***Comprehensive Remedial Design/Remedial
Action Work Plan Addendum for V-Tanks Early
Remedial Action for the Test Area North, Waste
Area Group 1, Operable Unit 1-10, Group 2 Sites***

**DOE/ID-11075
Revision 0**

Appendix D
Agency Response Comments

Figure 1-2. Area of contamination and site structures.

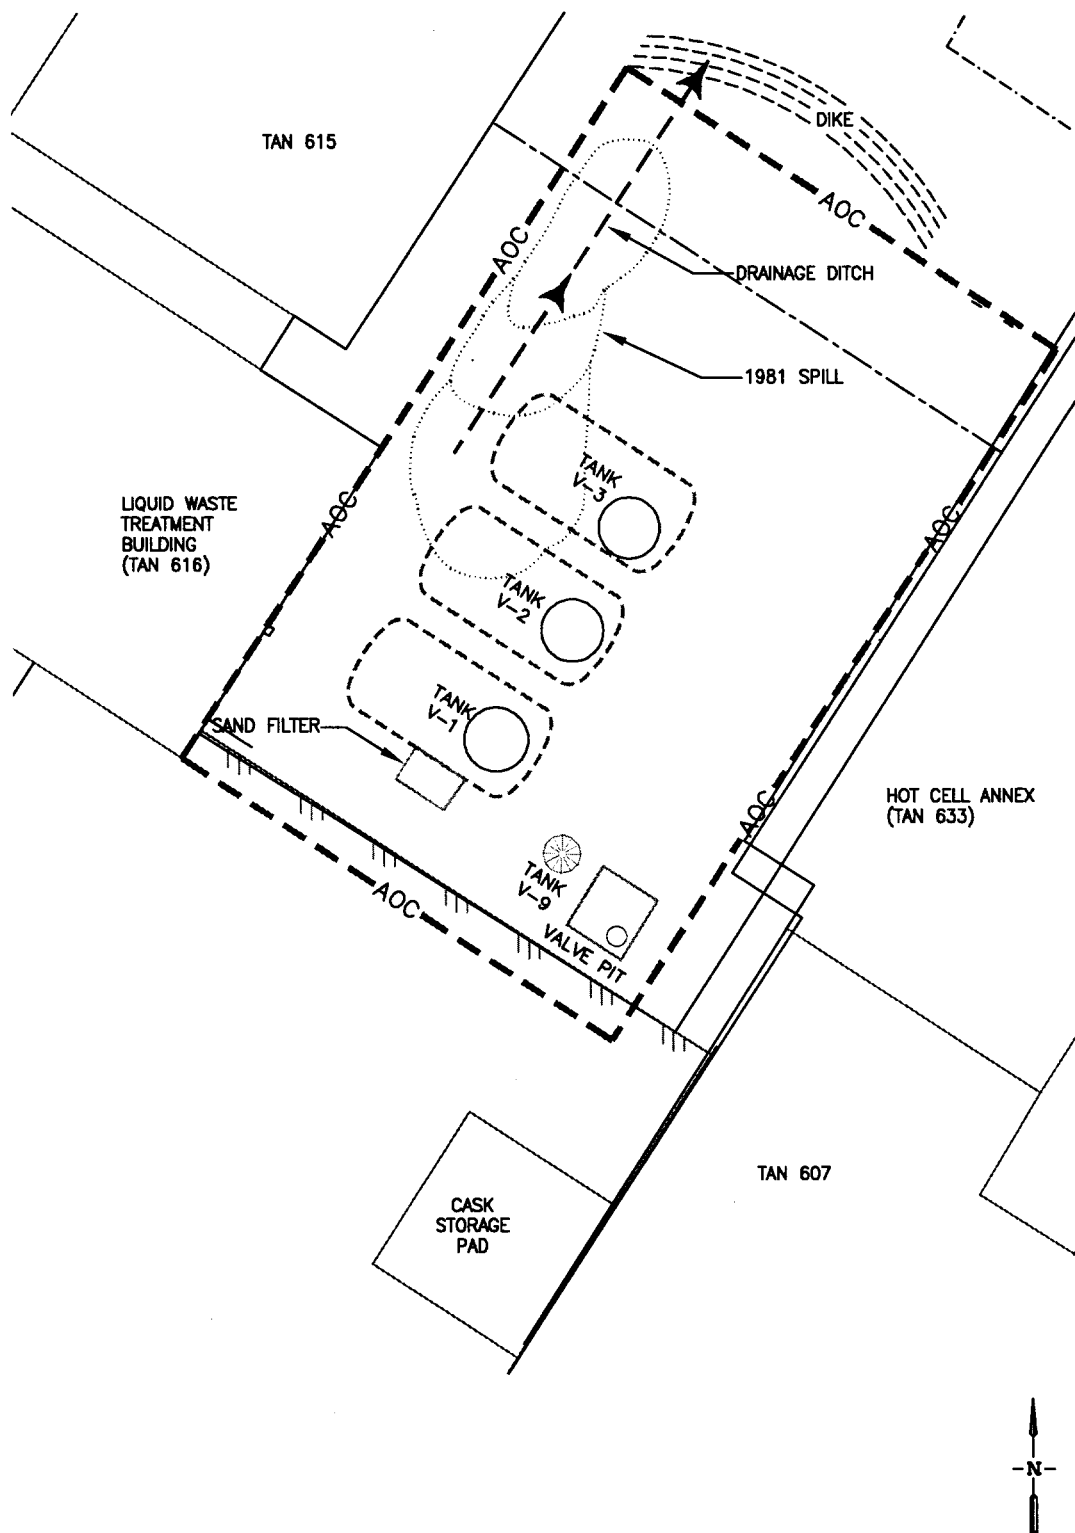
7	1.2.1.2	1-5	Second Paragraph, Third Sentence: The scale on Figure 1-1 shows the TSF-09 site to be approximately 25' x 40'. TSF-18 appears to be 10' x 10'. Together they do not quite appear to equal the estimated 50' by 80' as the section describes. No scale is indicated on Figure 1-2 where the AOC is outlined. It is recommended that one be included to help provide a perspective for the size of the AOC.	A scale will be added to Figure 1-2.

Figure 6-1. The V-Tank line inspection and relocation—plan view.

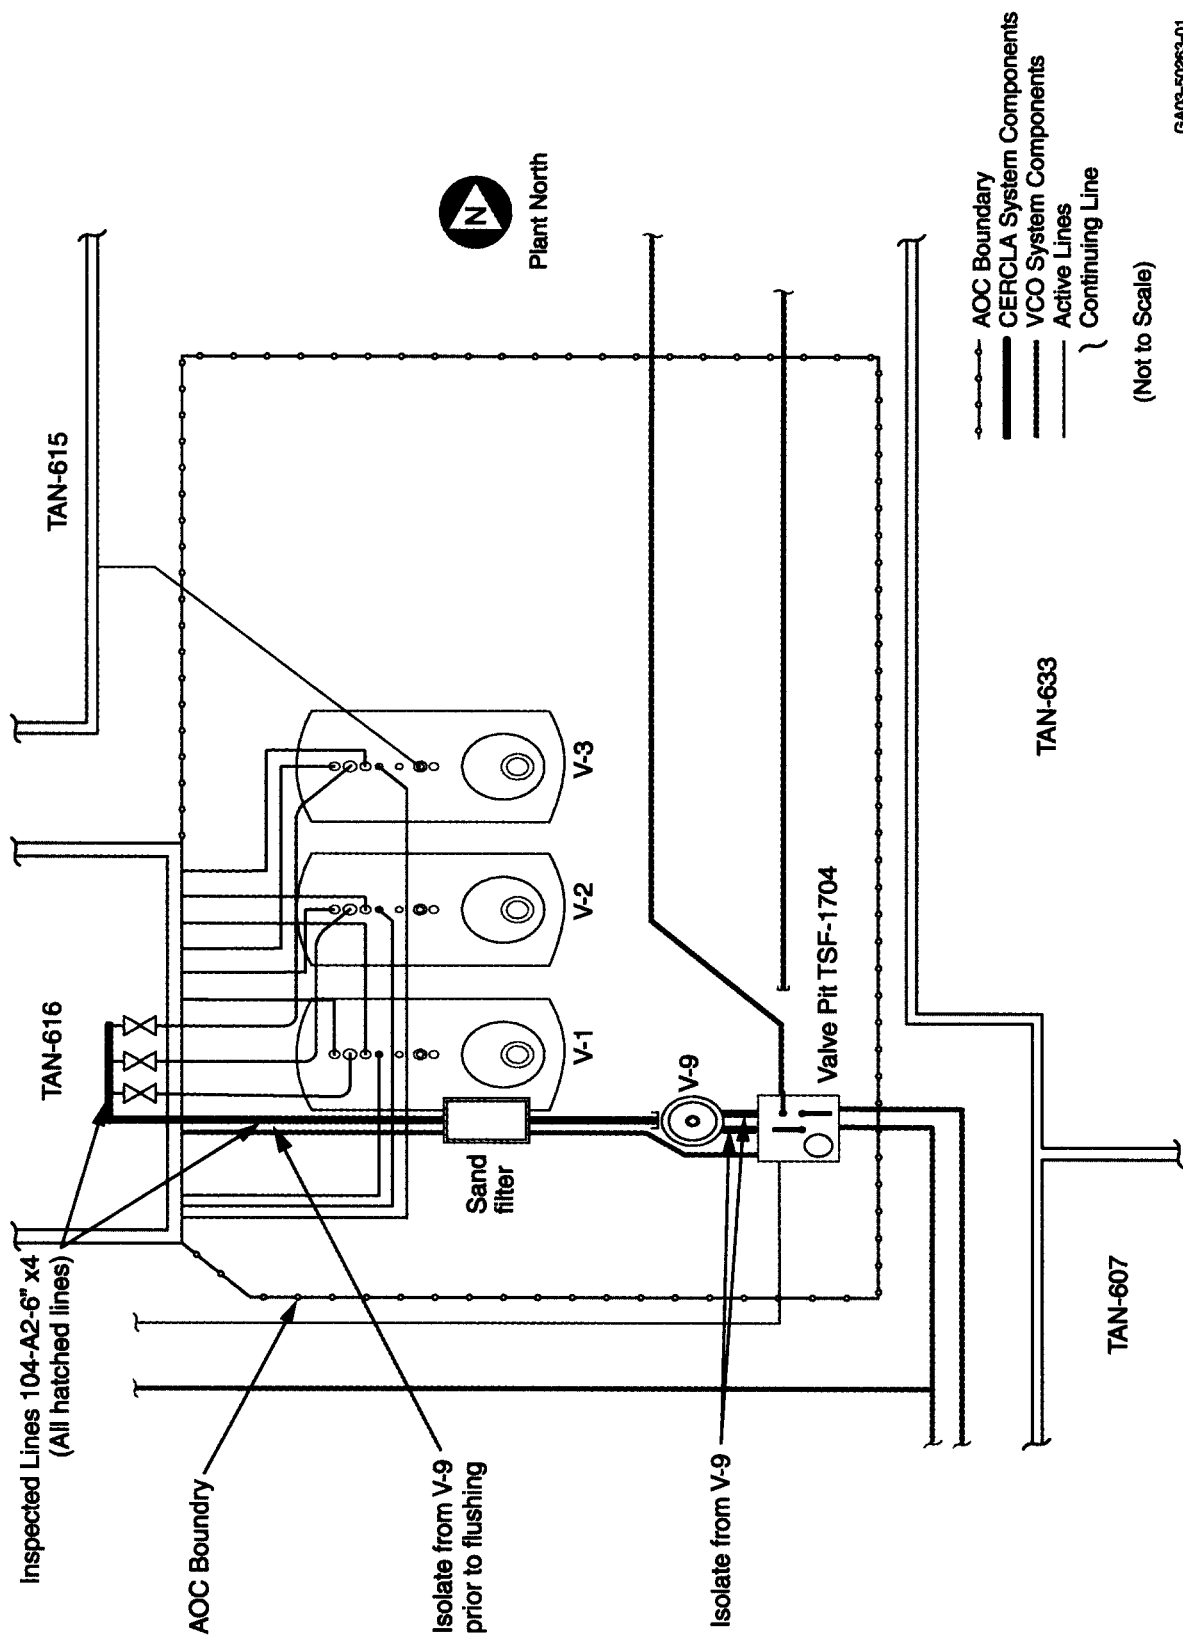
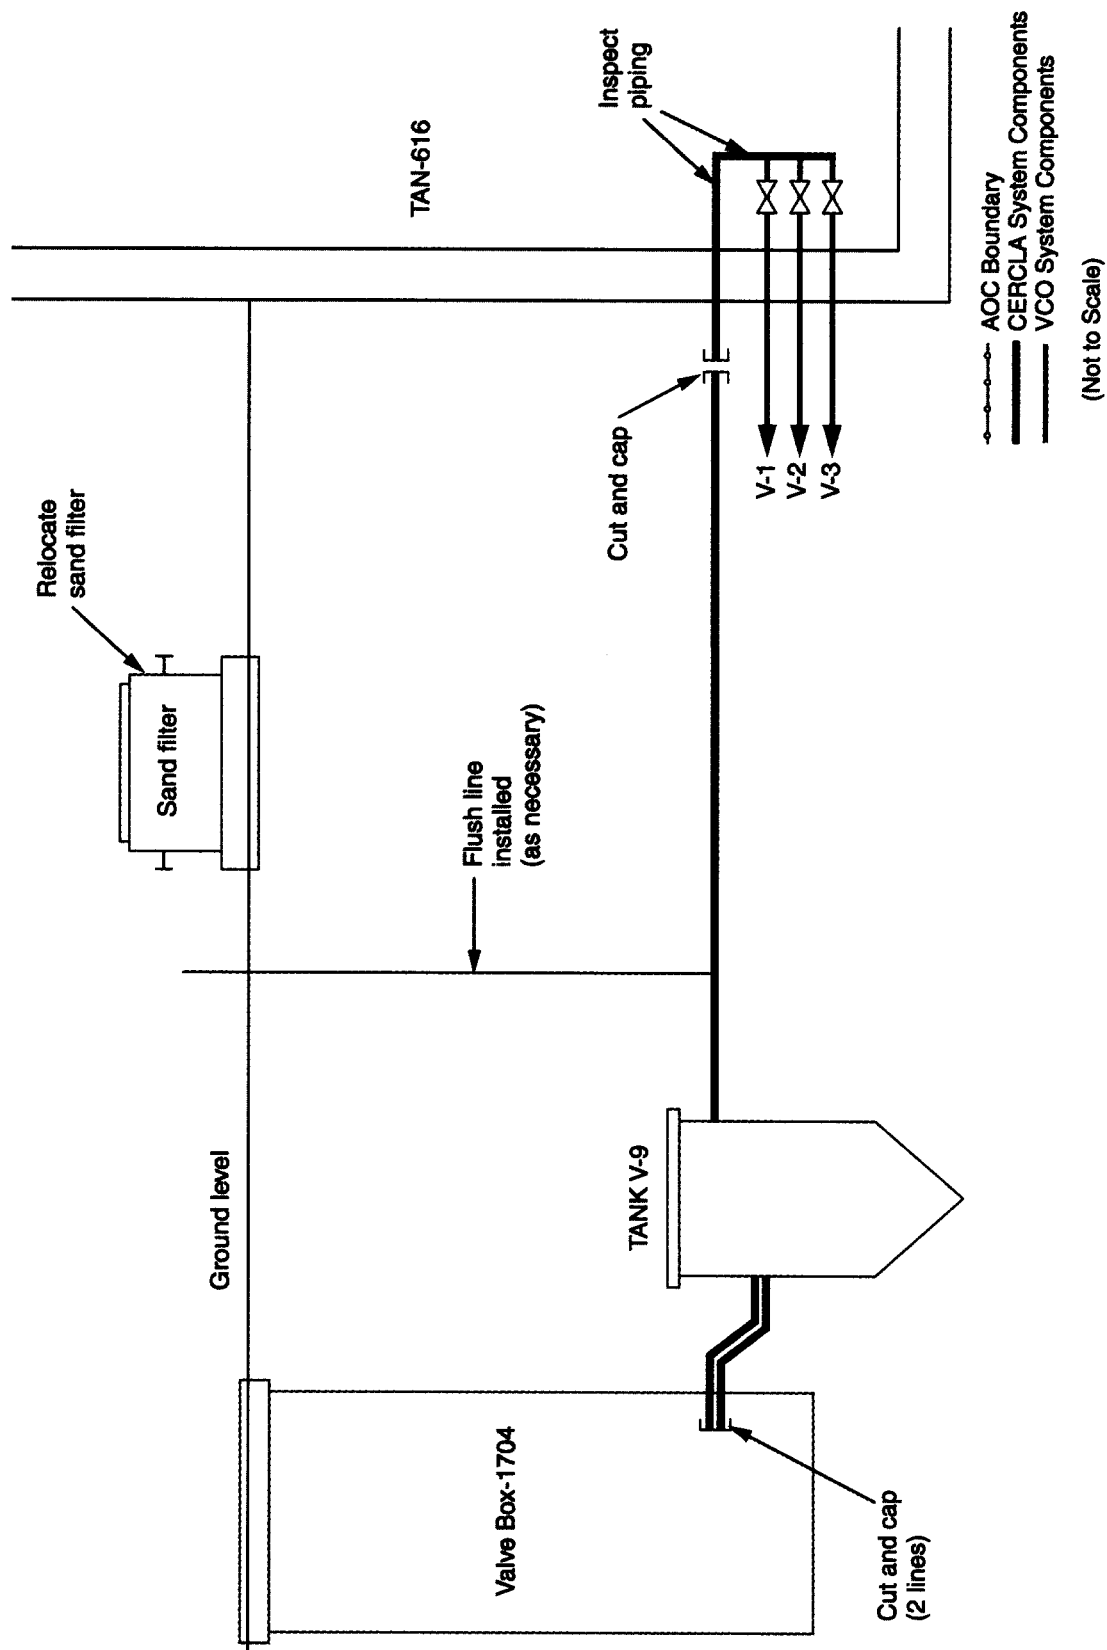
18	4.3.1	4-3	References to the piping diagrams of Figures 6-1 and 6-2 would benefit the reader while reviewing these field descriptions.	Comment accepted. A reference to Figures 6-1 and 6-2 has been added to the second paragraph.
19	6.1.1	6-2	First Paragraph: Although it is mentioned several times that a prefinal inspection by the agencies will not be conducted for the early remedial action, it should also mention that a prefinal inspection would accompany the final remedial action.	Comment accepted. "A prefinal inspection will accompany the final remedial action:" has been added to the end of the first paragraph.
20	6.2.3.1	6-4	Third Sentence: Please provide more information on the "approved CERCLA waste storage area," or provide a reference where such information can be found.	The reader is referred to the Waste Management Plan for a description of the "approved CERCLA Waste Storage Area"

ITEM NUMBER	SECTION NUMBER	PAGE NUMBER	COMMENT	RESOLUTION
13	2.2	2-1	<p>Second Paragraph:</p> <p>a) Although it is assumed that any fluids used for flushing of the V-9 Tank piping will be minimal in volume if this action is necessary, please ensure that any additional liquids in Tanks V-1 and V-2 will not have a negative impact on the remedial action for these tanks.</p> <p>b) Following this description of proposed activities is difficult to follow/visualize. Figure 6-2 provides a very illustrative cross-section that could be referenced for Section 2.2. Please consider moving the same Figure into Section 2.0 (and renaming it to comport with the section) or reference Figure 6-2 in the latter section. The way it is currently stated, the liquid that is flushed will end up in TAN -616 and Tanks V-1 and V-2. If the intent is to flush the liquid from V-9 through the valve system in the basement of TAN-616 into Tanks V-1 or V-2, then the sentence should be reworded</p>	<p>a) Comment accepted. The following sentence has been added to the paragraph. "Placing this additional liquid in Tanks V-1 and V-2 will not have a negative impact on the remedial action for these tanks.</p> <p>b) Comment accepted. The third sentence was re-worded "The flush would be from the V-9 outlet through "downstream" piping via the valve system in the basement of TAN 616 into Tank V-1 or V-2 for proper management." "This is further discussed in Section 6 and shown in Figure 6-2" has been added to the paragraph.</p>
